Access Compliance Report

Public Rights-of-Way

Intersection ID: 7952	Main Street: JULIA_AV	Cross Street: CARMINE_ST	Location: SW
ADA ID: E9A354A8C3B7	Ramp Type: PerpDiag	Initial Pass/Fail: Fail	Overall Compliance: No
Severity Score: 21.25			
Codes/Mitigation Info/Possible Solution		Field Measurements/Component Compliance

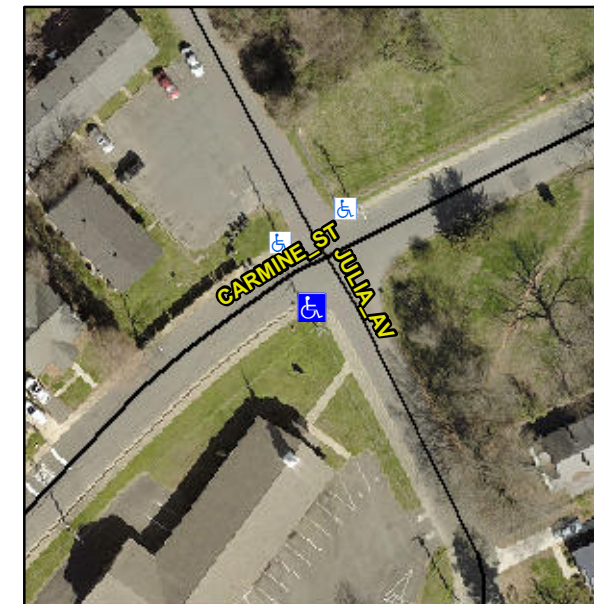
Not Found, R304.5.1, R304.2.2

Compliance	Description	Data	Compliance	Description	Data
N/A	Ramp Length (in)	48.0	No	Ramp Slope (%)	9.6
No	Ramp Width (in)	46.0	Yes	Ramp XSlope (%)	1.7
N/A	Flare Type LT	N/A	N/A	Flare Type RT	N/A
N/A	Flare Slope LT (%)	N/A	N/A	Flare Slope RT (%)	N/A
N/A	Flare Traversable LT?	N/A	N/A	Flare Traversable RT?	N/A
N/A	Landing Length (in)	N/A	N/A	DWS Provided?	N/A
N/A	Landing Width (in)	N/A	N/A	DWS Contrast?	N/A
N/A	Landing Slope (%)	N/A	N/A	DWS Length (in)	N/A
N/A	Landing X Slope (%)	N/A	N/A	DWS Full Width?	N/A
N/A	Landing Curb? (Y/N)	N/A	N/A	DWS Offset (in)	N/A
N/A	Shared Landing?	N/A			
N/A	Gutter Ponding?	N/A	N/A	Gutter Slope (%)	N/A
N/A	Gutter Lip Ht (in)	N/A	N/A	Gutter X Slope (%)	N/A
N/A	Painted X Walk1?	No	N/A	Painted X Walk2?	No
	X Walk 1 Direction	To E		X Walk 2 Direction	To N
N/A	X Walk 1 Width (in)	N/A	N/A	X Walk 2 Width (in)	N/A
	X Walk 1 Slope (%)	4.2		X Walk 2 Slope (%)	11.9
	X Walk 1 X Slope (%)	7.4		X Walk 2 X Slope (%)	3.6

Remove & Replace Curb Ramp With Two New Directional Ramps or Equivalent.
